**CITY OF LA VISTA
MAYOR AND CITY COUNCIL REPORT
AUGUST 20, 2024 AGENDA**

Subject:	Type:	Submitted By:
CONDITIONAL USE PERMIT – BEAR CREEK APARTMENTS	◆ RESOLUTION ORDINANCE RECEIVE/FILE	CALE BRODERSEN ASSOCIATE CITY PLANNER

**CITY OF LA VISTA
PLANNING DIVISION
RECOMMENDATION REPORT**

CASE NUMBERS: PPUD23-0006; PCUP23-0010; PRP23-0004

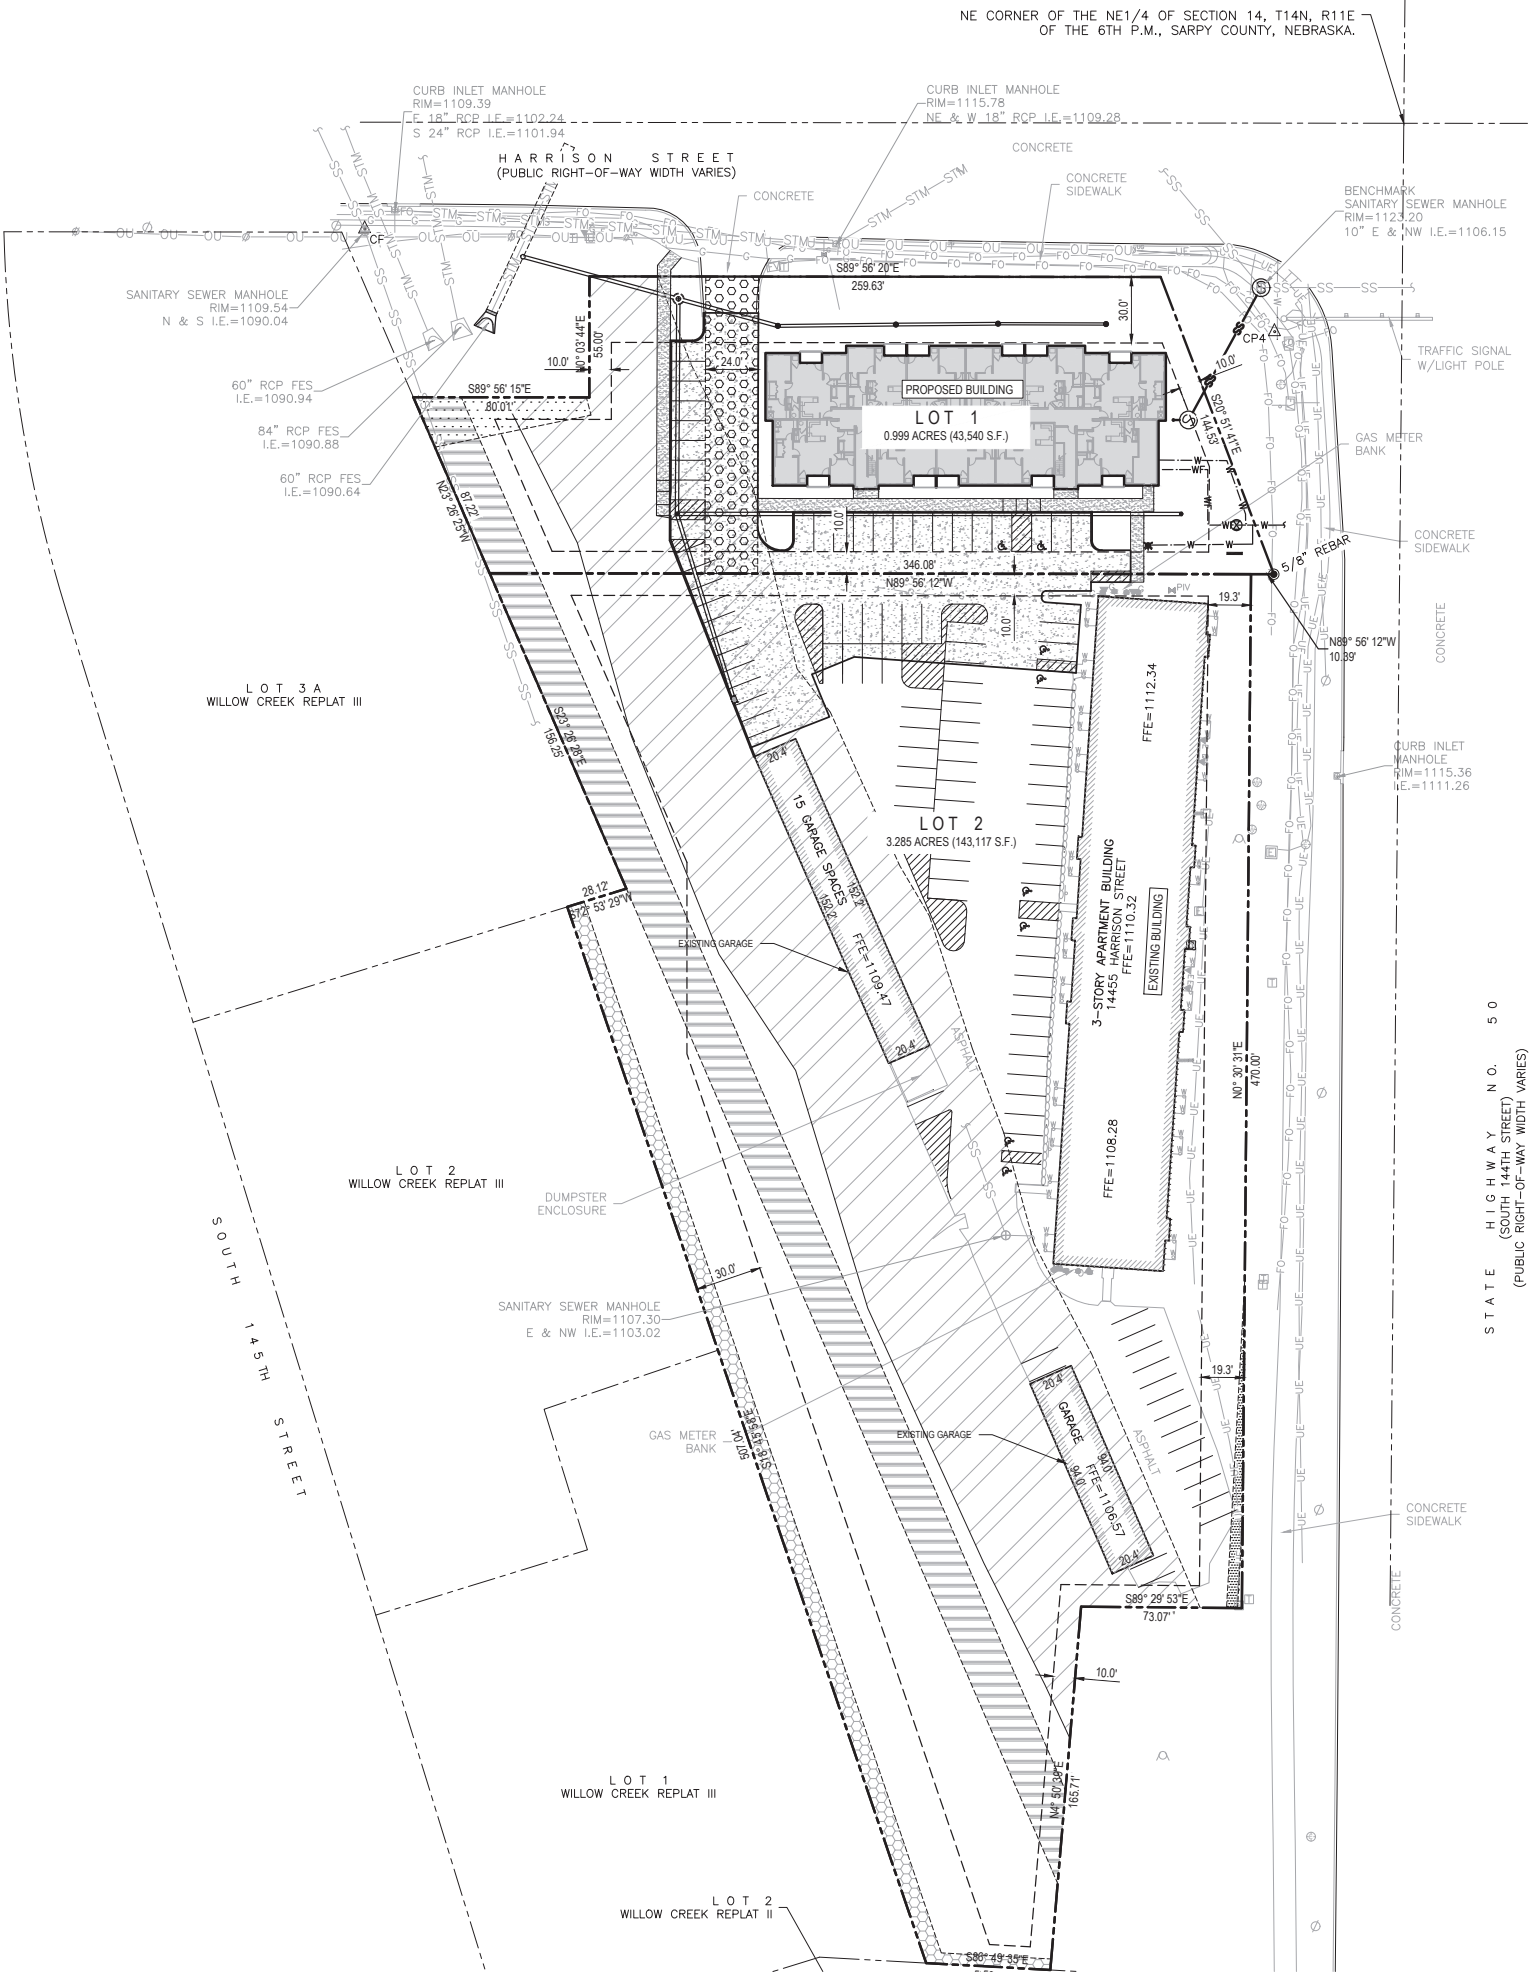
19. Regarding Section 3.03.07, please provide the size, flow lines, and elevation of the existing sanitary & storm sewer.
The inverts and sizes for both sanitary and storm sewer are shown on Exhibit A, Preliminary Plat.

SOUTH ELEVATION

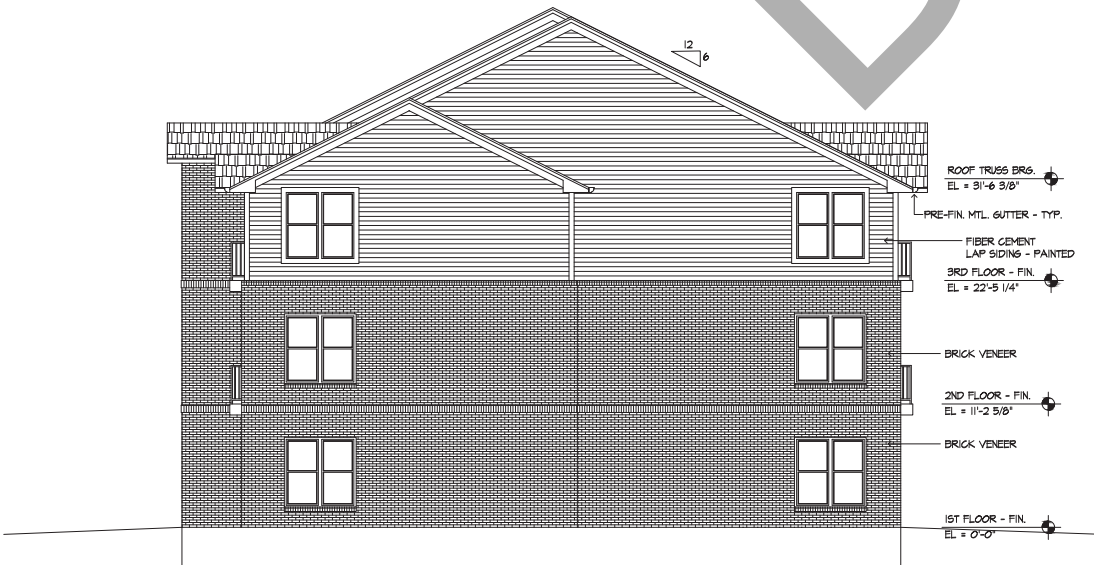
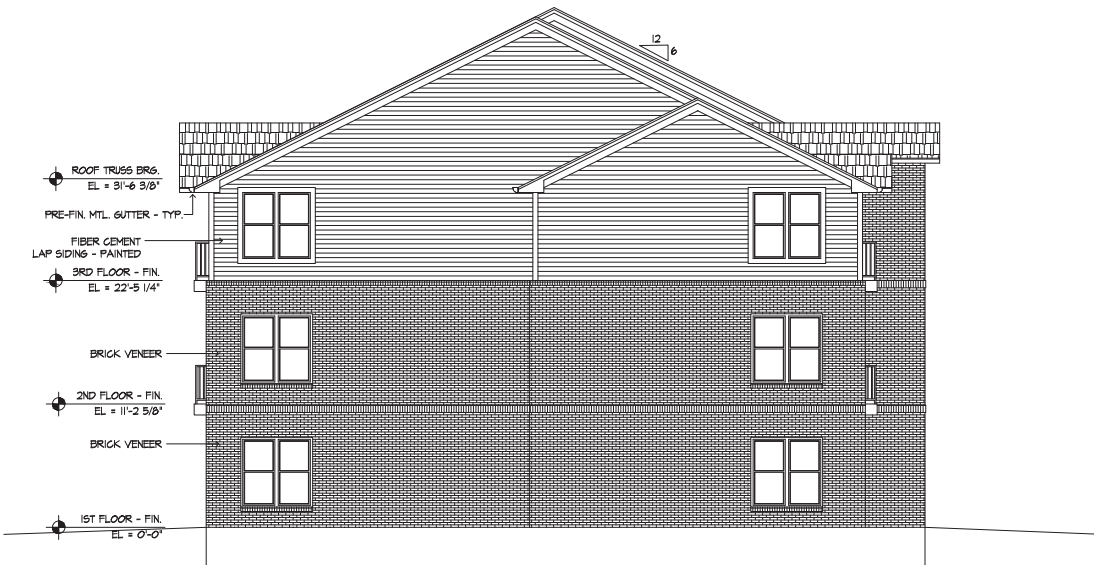
13. Regarding Section 5.15.05.07, please provide a rendering of the proposed buildings, inclusive of elevations and other applicable pertinent information.
Rendering image of the proposed apartment building has been included in the resubmittal.
